REQUEST FOR INFORMATION **DATE:** July 08, 2016 **NO.:** RFI-194

Project Name: 15051-Webster University Interdisciplinary Science Building Project No.: 15051

Subject: 3 Way Valve Detail

HEATING RECOVERY COIL PIPING DETAIL

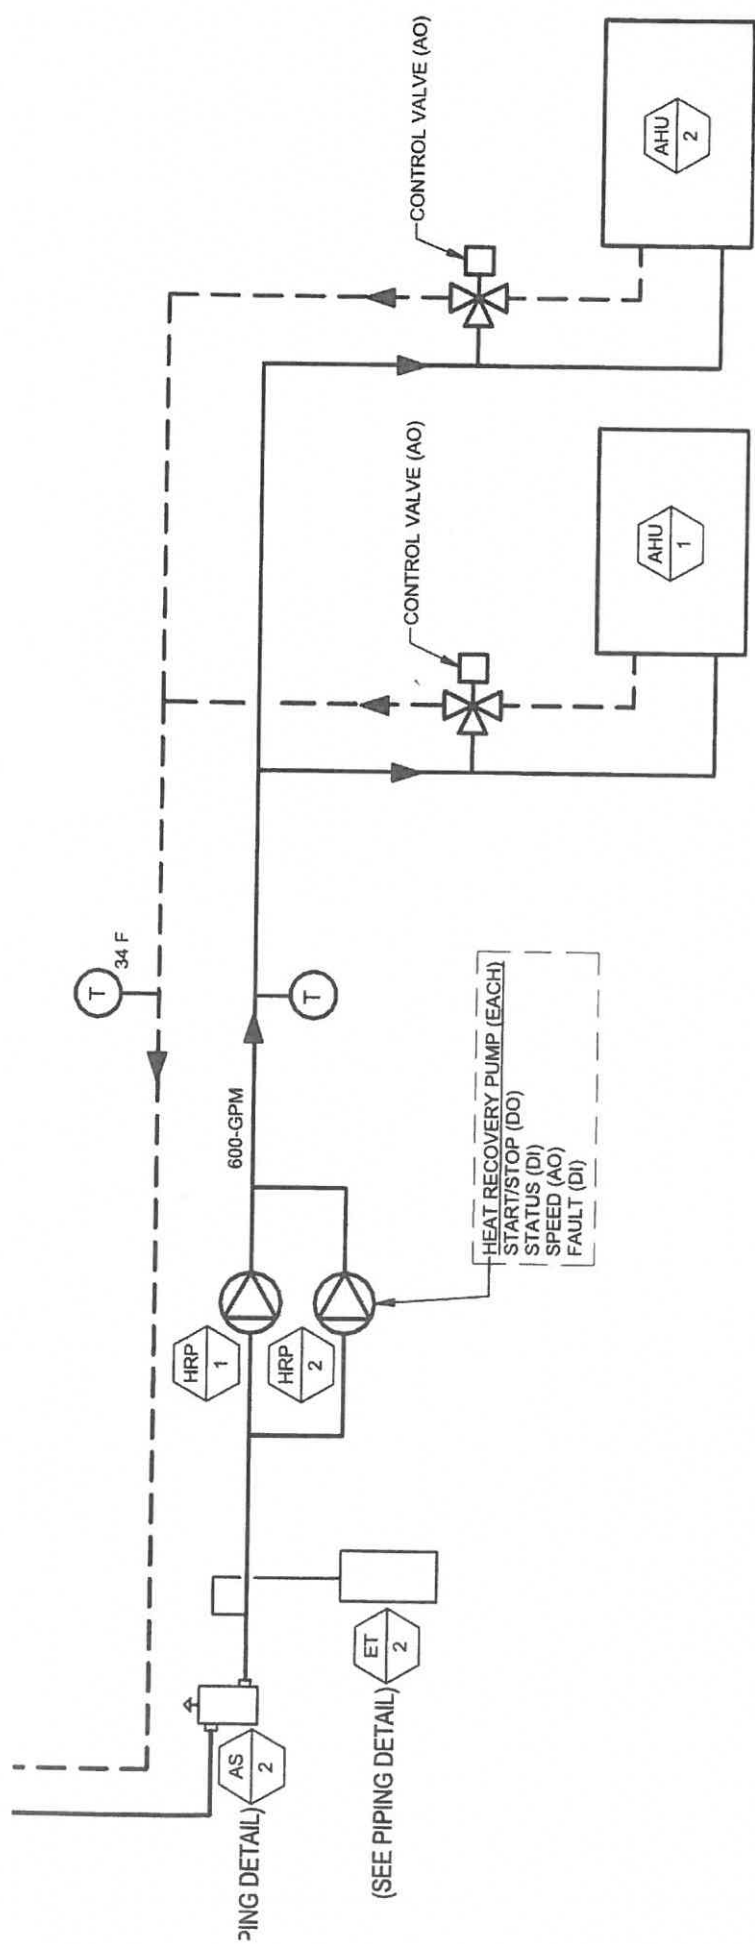
A detail showing the 3-way valve in the heat recovery system is not shown.

Please provide a detail for the 3-way valve in the heat recovery system.

Is a balancing valve required where indicated in the attached mark-up?

Suggestion: Attached detail is ICON's recommendation pending EOR approval

Heat recovery coils in the outside air stream require three-way control valves as shown on piping diagram. Control valves are not required on heat recovery coils in the exhaust air stream. Detail attached is acceptable, except provide strainer in supply line as recommended by control valve manufacturer and as specified in 230600. A balancing valve the bypass line is not required.
